AMENDMENT OF SOLICITATION/MODIFICATION OF CONTRACT				1. CONTRACT ID CODE		PAGE OF PAGES	
2. AMENDMENT/MODIFICATION NO.		3. EFFECTIVE DATE		4. REQUISITION/PURCHASE REQ. NO.		5. PROJECT NO. (If applicable)	
6. ISSUED BY		CODE		7. ADMINISTERED BY (If other than Item 6)		CODE	
8. NAME AND ADDRESS OF CONTRACTOR (No., street, county, State and ZIP Code)				(X)		9A. AMENDMENT OF SOLICITATION NO.	
						9B. DATED (SEE ITEM 11)	
						10A. MODIFICATION OF CONTRACT/ORDER NO.	
						10B. DATED (SEE ITEM 11)	
CODE		FACILITY CODE

Item 14. Continued.

2
E003 E003 **FLUSH POLE BASE DETAIL**
SCALE: NONE

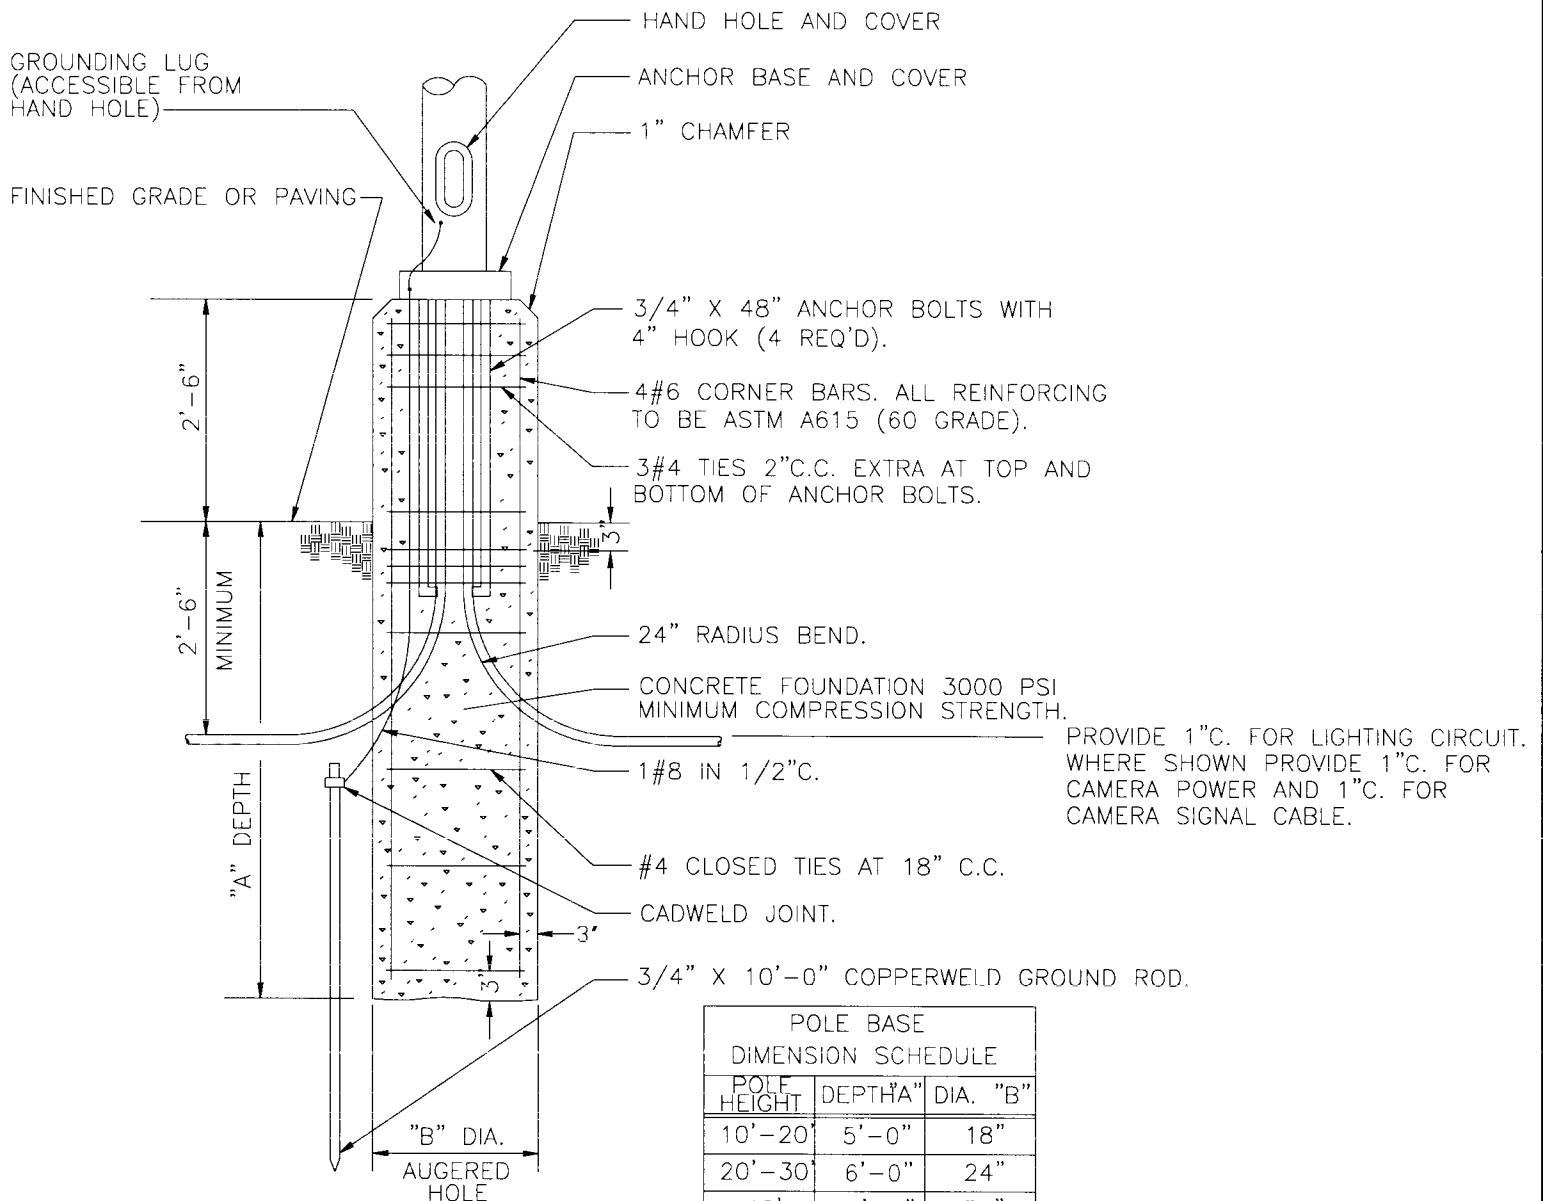
5. Sheet E-003 – Add the following attached details to this drawing:

RAISED POLE BASE DETAIL
FLUSH POLE BASE DETAIL
